PRODUCT / PROCESS CHANGE NOTIFICATION

1.1 Company		STMicroelectronics International N.V
1.2 PCN No.	EMBEDDED PROCESSING/26/16419	
1.3 Title of PCN	Amkor ATJ (Japan) additional assembly line for STM32H74x & STM32H75x listed products in LQFP20x20 and LQFP14x14 packages	
1.4 Product Category	STM32H742x, STM32H743x, STM32H750 and STM32H753x.	
1.5 Issue date	2026-07-09

PCN16419 – Additional information

Amkor ATJ (Japan) additional assembly line for STM32H74x and STM32H75x listed products in LQFP 20x20 and LQFP 14x14 packages.

The standard marking fields example below
for **LQFP 144L 20x20** package

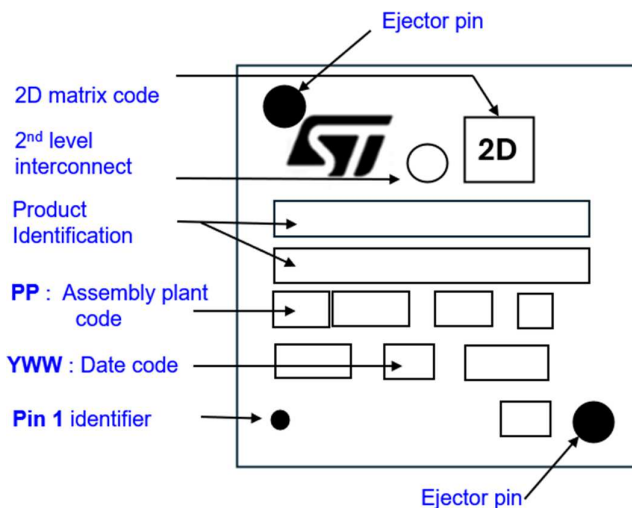
Pin1 identifier may change in terms of size and positioning however remaining near pin1's edge.
Marking position and size may be different upon assembly site, without any loss of information.

Table 2: Marking Example with Commercial product

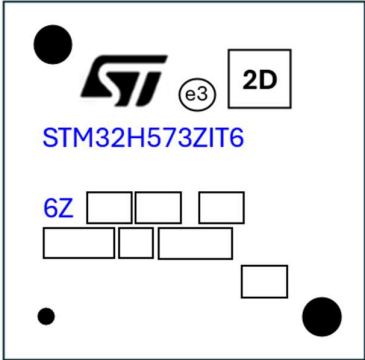
Package example	Amkor ATJ (Japan)
LQFP 14x14 100L (ie: STM32H743VGT6)	 The diagram shows the marking layout for an LQFP 14x14 100L package. It includes the ST logo, an 'e3' symbol in a circle, and a '2D' symbol in a box. The part number 'STM32H743VGT' is printed in blue, followed by '6' and '6Z' in blue. There are several empty rectangular boxes for additional marking, and a small black dot in the bottom left corner.
LQFP 20x20 144L (ie: STM32H742ZIT6)	 The diagram shows the marking layout for an LQFP 20x20 144L package. It includes the ST logo, an 'e3' symbol in a circle, and a '2D' symbol in a box. The part number 'STM32H573ZIT6' is printed in blue, followed by '6Z' in blue. There are several empty rectangular boxes for additional marking, and two black dots in the bottom left and bottom right corners.
